Subject: AP1000 COL Standard Technical Report Submittal of APP-GW-GLR-101 (TR 101) Revision 1

1. APP-GW-GLR-101, Revision 1, "AP1000 Probabilistic Risk Assessment Site-Specific Considerations," Technical Report Number 101

The following DCD markup identifies how COL application Final Safety Analysis Reports should be prepared to incorporate the subject change. This section represents the original DCD Section 19.58 markup, as identified in APP-GW-GLR-101, Revision 0. No changes have been made to this text in this revision.

Figure 19.58~~.2.3.3-1~~:

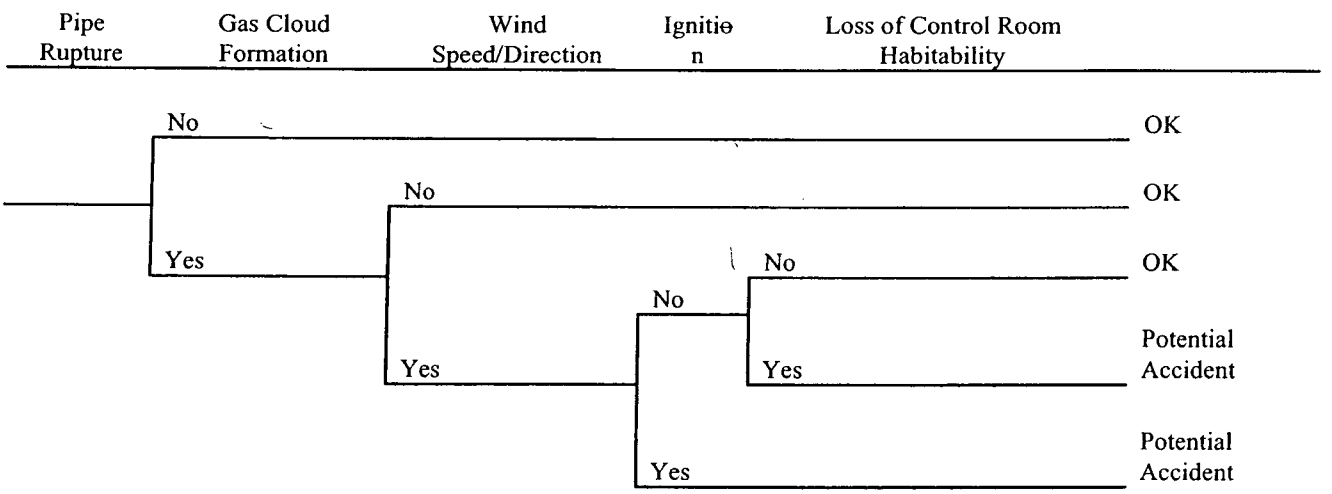
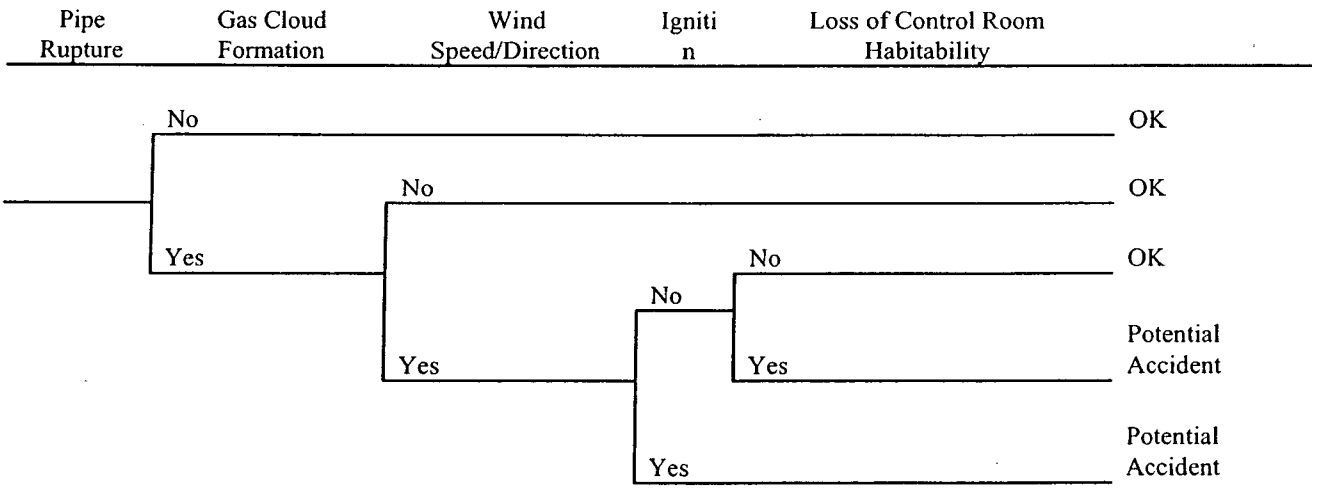
~~Consider~~ Figure 19.58~~.2.3.3~~-1 to further evaluate the probability of this accident. When then considering the probability of forming a dense gas cloud, and the probability of the wind speed and direction to be in the ranges necessary to transport the gas cloud 5800 feet to the site, without dispersing the gas, including ignition of the gas cloud on-site in a location that may challenge the plant, this probability becomes very low.

Figure 19.58-1 to further evaluate the probability of this accident. When then considering the probability of forming a dense gas cloud, and the probability of the wind speed and direction to be in the ranges necessary to transport the gas cloud 5800 feet to the site, without dispersing the gas, including ignition of the gas cloud onsite in a location that may challenge the plant, this probability becomes very low.

~~Figure 19.59-2~~

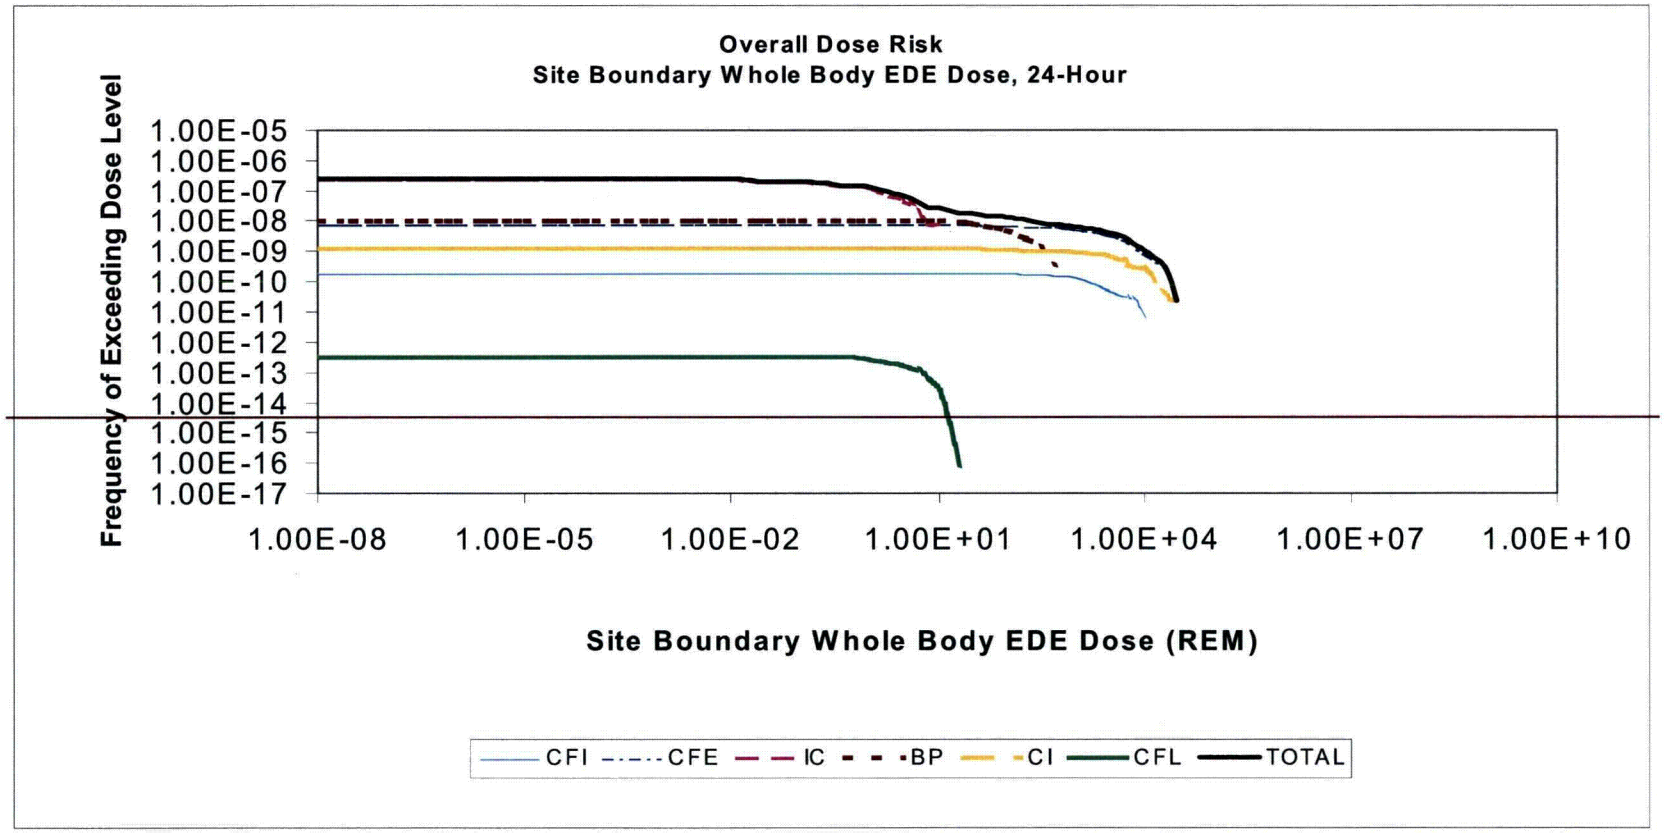
~~Figure 19.59-2 shows the 24 hour, whole body EDE site boundary dose cumulative distribution.~~

Delete Figure 19.59-2:
